Preliminary Plan 120100100: Little Bennett Creek

Staff Recommendation: *Approval with Conditions*

Attachment A –Preliminary Plan
Attachment B – Preliminary FCP
Attachment C – Well & Septic Approval
Attachment D – Fire Marshal Approval
Attachment E – MCDOT Approval
Attachment F – DPS Stormwater

PRELIMINARY PLAN
LITTLE BENNETT CREEK
(Parcel 660; Tax Map FX 22)
Montgomery County, Maryland

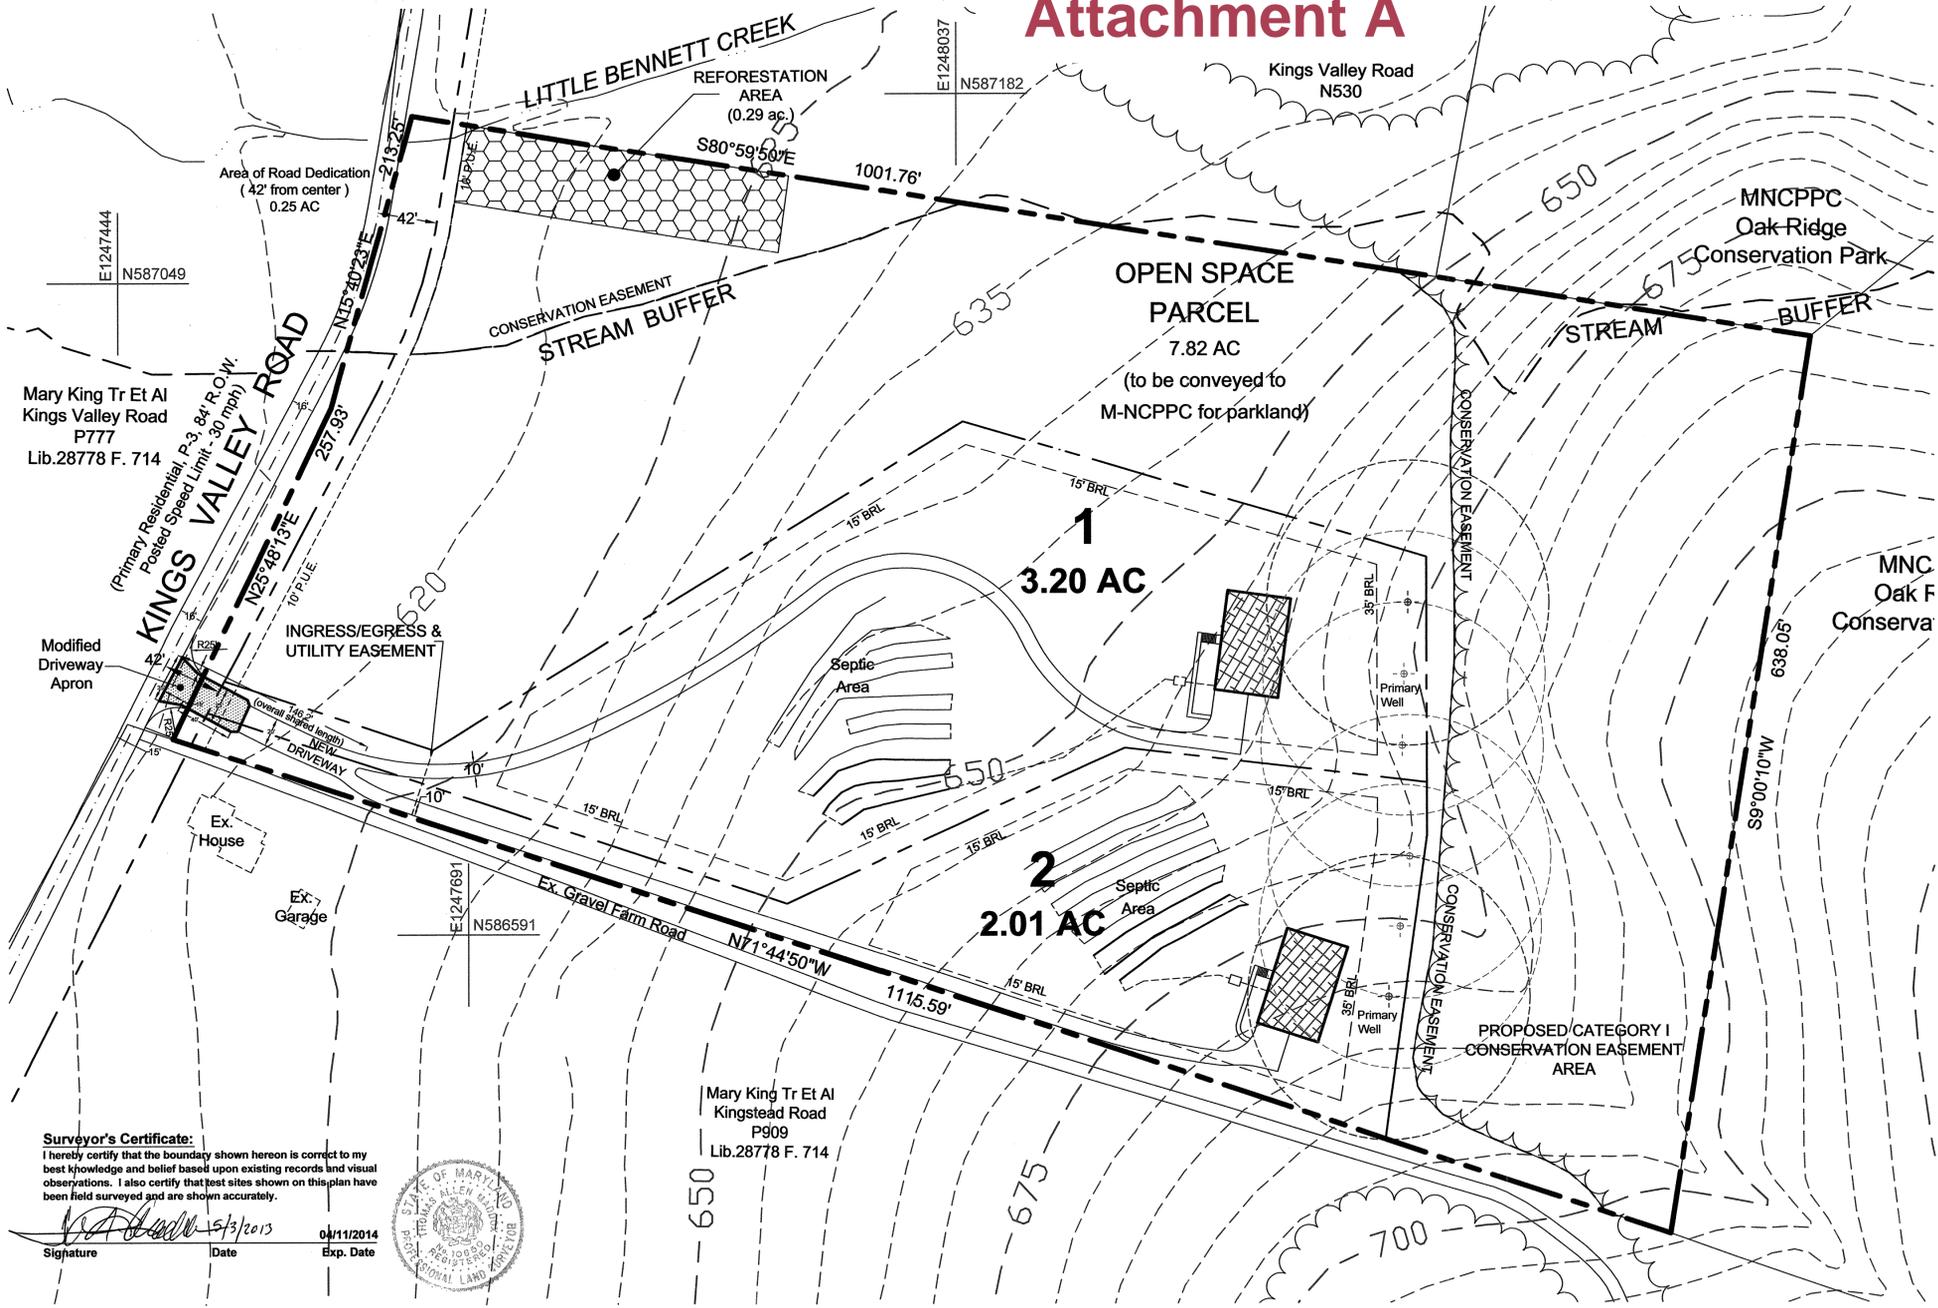
We have completed our review of the amended preliminary plan dated November 4, 2010. An earlier version of this plan was reviewed by the Development Review Committee at its meeting on January 19, 2010. We recommend approval of the plan subject to the following comments:

1. Necessary dedication for future widening of Kings Valley Road to achieve an ultimate eighty four (84) foot wide right-of-way per MCDOT Design Standard No. MC-2003.14 ("Primary/Principal Secondary Residential Street – Open Section").

2. Grant necessary slope and drainage easements. Slope easements are to be determined by study or set at the building restriction line.
3. The consultant's storm drain study has been accepted. We note that the nearby (previously existing) fifteen (15) inch corrugated metal pipe has been replaced with a thirty six (36) inch corrugated metal pipe.

5. Record plat to reflect a reciprocal ingress, egress, and public utilities easement to serve the lots accessed by the proposed private common driveway.

Concluding that a sidewalk is not needed to serve the two 2-3 acre lots proposed on this plan – but recognizing that a sidewalk may be needed at a future date along this primary classification road – we recommend requiring the applicant to construct a modified version of the aforementioned Standard MC-2003.14 in a way that retains the current rural character of the road while protecting the ability to implement the sidewalk if needed in the future. We recommend the applicant be required to provide the following improvements across the site frontage:

- Grade and sod the roadway shoulder at 2% cross-slope to a point fifteen (15) feet from the centerline, per Standard MC-2003.14 – while maintaining the existing pavement width

- Grade and construct sod shoulder and flat bottom side ditch in accordance with Standard MC-2003.14
 - Grade and construct sod shelf [for potential future five (5) foot wide sidewalk] and two (2) foot wide maintenance panel in accordance with Standard MC-2003.14

- Plant street trees
 - Transition back to existing ground as necessary at each end of the site
8. Relocation of utilities along existing roads to accommodate the required roadway improvements shall be the responsibility of the applicant.

PRELIMINARY FOREST CONSERVATION PLAN
LITTLE BENNETT CREEK
 (Parcel 660; Tax Map FX 22)
Montgomery County, Maryland

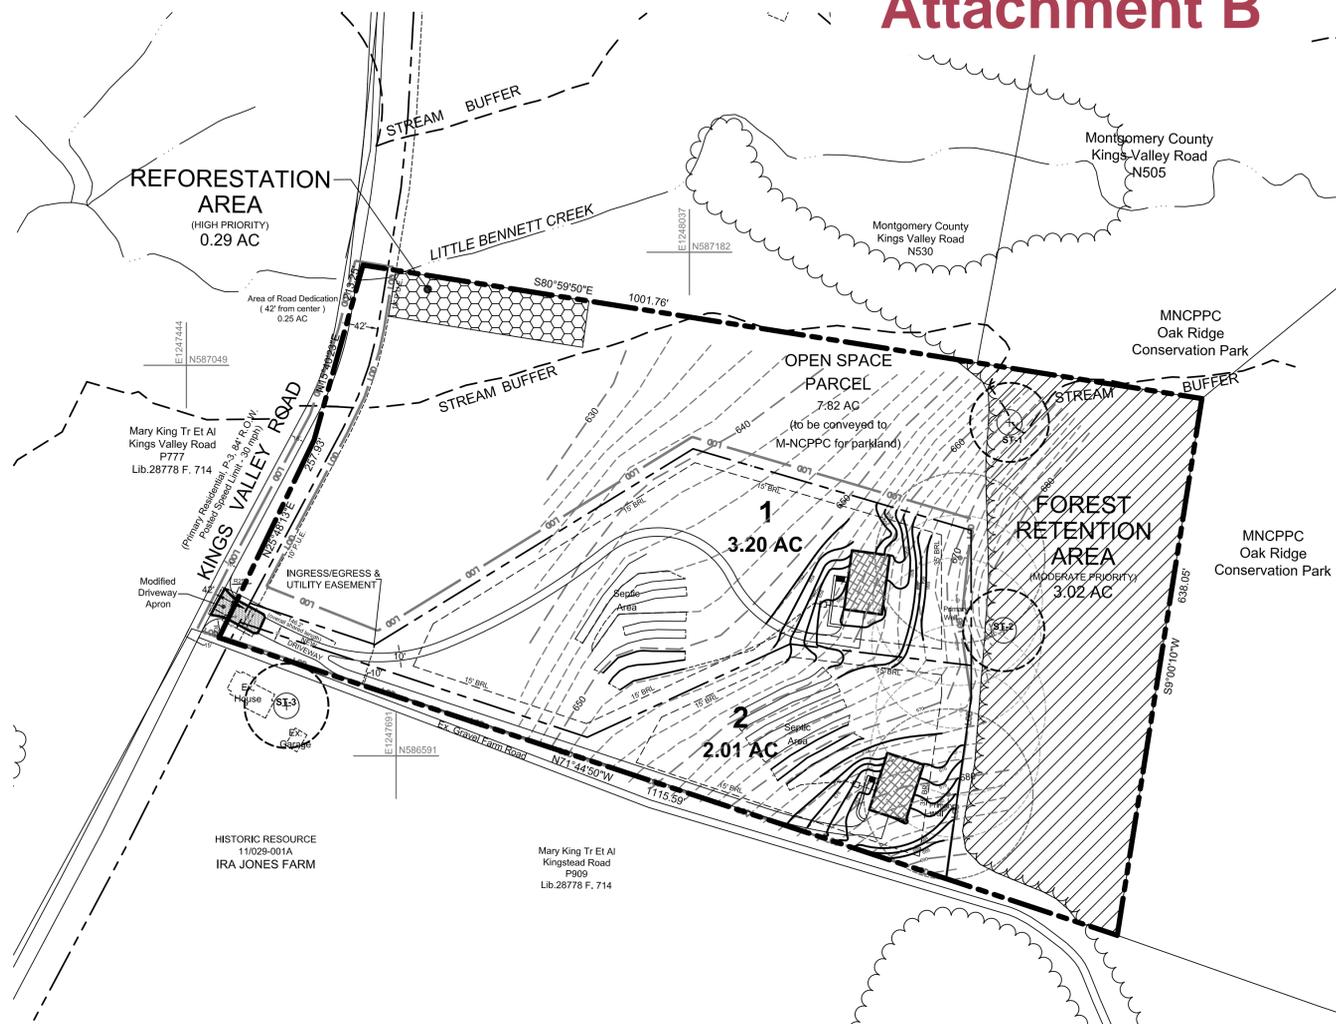
- a. Relocate 0.29 acre planting area adjacent to the existing forest on the Open Space Parcel to enlarge the existing forest stand.
3. The Planning Board has accepted the recommendations of the Montgomery County Department of Transportation (“MCDOT”) in its letter dated January 29, 2013, and does hereby incorporate them as conditions of the Preliminary Plan approval. Therefore, the Applicant must comply with each of the recommendations as set forth in the letter, which may be amended by MCDOT provided that the amendments do not conflict with other conditions of the Preliminary Plan approval.

The forest conservation plan (FCP) (Attachment B) proposes no forest clearing and 3.02 acres forest retention; however, there is a 0.29 acre planting requirement. Section 22A-12(f) of the County code requires all agricultural and resource areas to have 25 percent of the net tract area in forest. Since the forest is less than 25% of the net tract, the applicant must plant forest to achieve the requirement. Therefore, the applicant must plant the additional acreage.

The applicant proposes to meet the planting requirement on-site within the unforested portion of the stream buffer on the northwestern corner of the property. Unforested stream buffers are the highest priority for on-site planting, however in this particular case with the entire area being dedicated to MNCPPC parks and the small amount of planting required a small isolated pocket of forest would be created. Staff recommends that the 0.29 acre planting requirement be moved so that it is located adjacent to the existing onsite forest onsite. Section 22A-12(e) of the County code identifies priority planting areas as “stream buffer areas, connections between and additions to forested areas, critical habitat areas, topographically unstable areas, and lands use and road buffers.” Even though the planting is not within a stream buffer the location requested by staff is still a priority planting area according the County code. In addition, the likelihood of planting adjacent to an existing forest versus creating an isolated forest has a greater chance to succeed as a naturally regenerating forest.
